- 3.1 Lot 17 (No. 581) Welshpool Road East, Wattle Grove - Proposed Warehouse/Storage and Incidental Office – DAP/25/03012

**Part C – Item 3.1 – LOT 17 (No. 581) WELSHPOOL ROAD
EAST, WATTLE GROVE – PROPOSED
WAREHOUSE/STORAGE & INCIDENTAL OFFICE**

**Form 1 – Responsible Authority Report
(Regulation 12)**

Road Realignment at intersection of Coldwell Road and Welshpool Road East

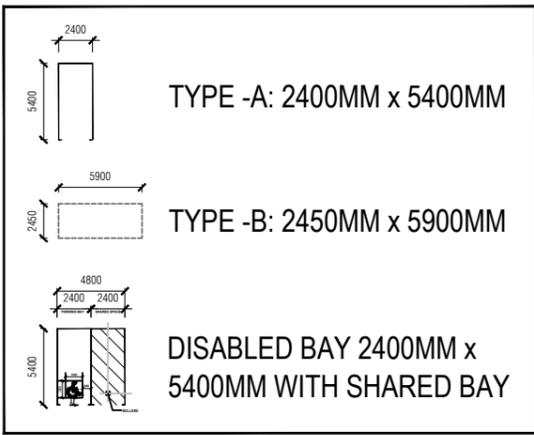
LPP19 identifies an eastern portion of the subject lot as subject to a future road alignment at the intersection of Coldwell Road and Welshpool Road East. To demonstrate consistency with LPP19, the applicant has designed the development to preserve the space reserved for the future road realignment.

The City is satisfied that the development design appropriately addresses the planned intersection upgrade. A condition has been recommended for the applicant/landowner to enter to an agreement (Deed) to allow the City of Kalamunda to obtain this portion of the lot. A similar condition in the absence of a DCP was recommended and approved in DAP/25/02903 within the City of Kalamunda locality. In support of this recommended condition, a letter signed by the City of Gosnells (refer Attachment 8) has been provided. Removal of this condition would prejudice future planning of the area and jeopardise the continued industrial development for the remainder of the MKSEA precinct.

SITE PLAN

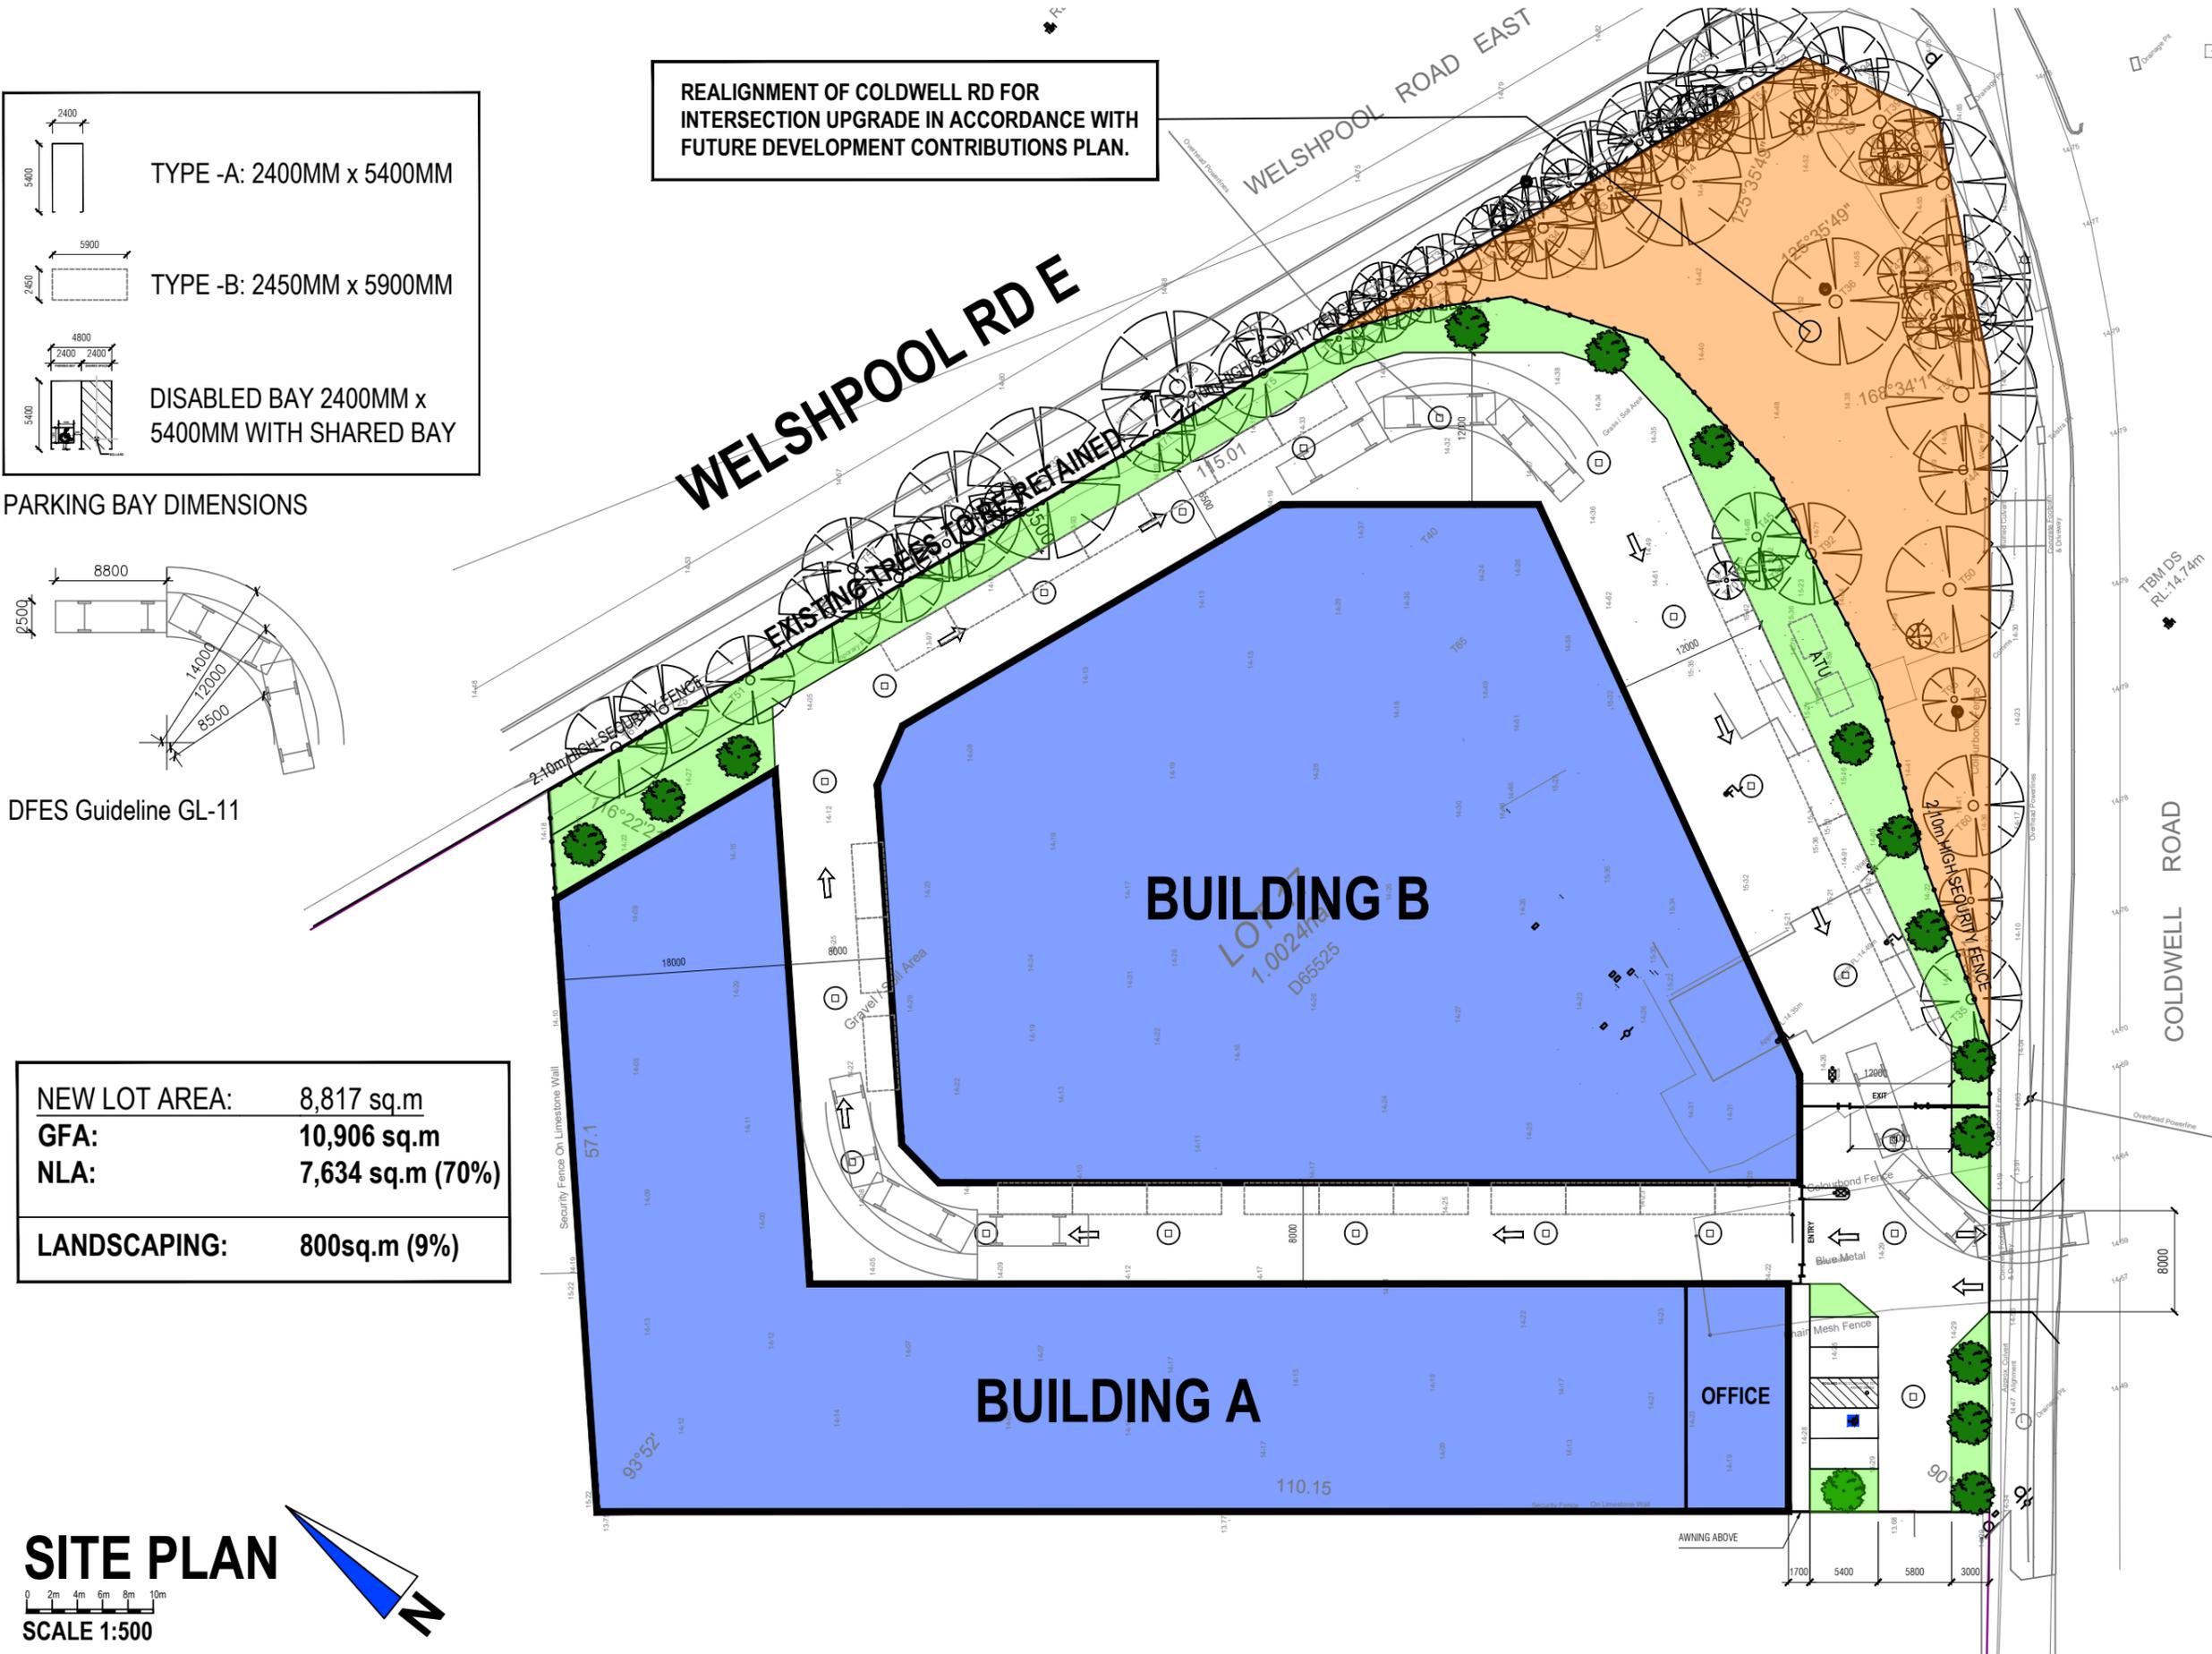
22. No development other than landscaping is to be located within the land requirement for the future upgrade of Welshpool Road East / Coldwell Road intersection as shown on the Site Plan prepared by Parsons Group, Dwg No.A100 (Rev B) dated 19 January 2026.

The development proposes a minimum 3.5m landscaping strip to the Welshpool Road East street frontage in lieu of the 4m required under LPP19. The provided landscape plan proposes extensive landscaping within the Welshpool Road East frontage. Trees along the Coldwell Road and Welshpool Road East frontage are proposed with a maximum pot size of 90L in lieu of the 100L minimum required. The variation is considered acceptable for the following reasons:
